TENDER FOR SUPPLY OF GEOTHERMAL WELLHEADS (KGN-GDD-091-2016)

Date: 1st December 2016

CLARIFICATION No. 2

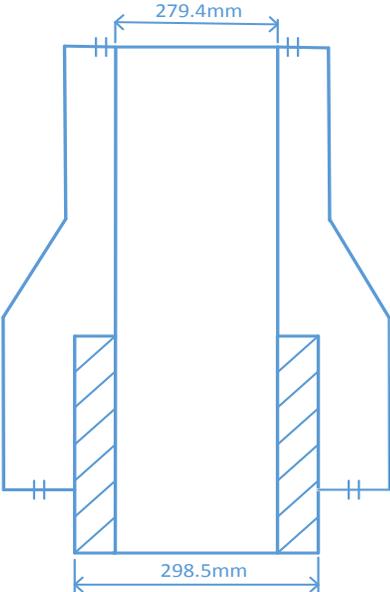
No.	BIDDER'S QUESTION	KENGEN'S RESPONSE
1	<p>Double studed adaptor flange 13 5/8" API 6A, 3000 psi ring joint (R-57) bottom x 10" ANSI 1500 (11" API 5000 psi) ring joint (R-54) top, complete with ASTM grade B6 stud bolts & nuts (20 sets) for 13 5/8" 3000 psi flange and 10"- Class 1500 flange (12 sets) and 4" long erosion shield welded on the bottom.</p> <p>Clarification 1: 4" Long erosion shield welded on the bottom, OD 298.5, ID 279.4</p> <p>In the past tenders of Kenya, it's never demanded as tender. And it's not API standard products. Please kindly clarify what this shield will protect? Protect the inner of 13-5/8" casing head when you drilling (Same function as ware bushing of API 6A)? Protect the master valve? (While, it get 11" ID, it will protect nothing for the valve.)</p> <p>Please kindly clarify, or remove this demand.</p> <p>Also we wish you could kindly give a draft drawing and material advice of it. (We prefer use 304 to do the shield, is that acceptable?</p>	<p>The double studed adaptor flange has a bore or ID of 279.4 mm. The erosion shield will be welded at the bottom of the 13 5/8" API 6A, 3000 psi flange. This flange will be mounted on a 13 5/8" API 6A, 3000 psi casing housing with a bore or ID of 317.5 mm. The erosion shield is meant to protect the bottom flange of the adaptor which has a smaller bore than the casing housing.</p> <p>304 stainless steel is acceptable material for the erosion shield. Below is a sketch</p>
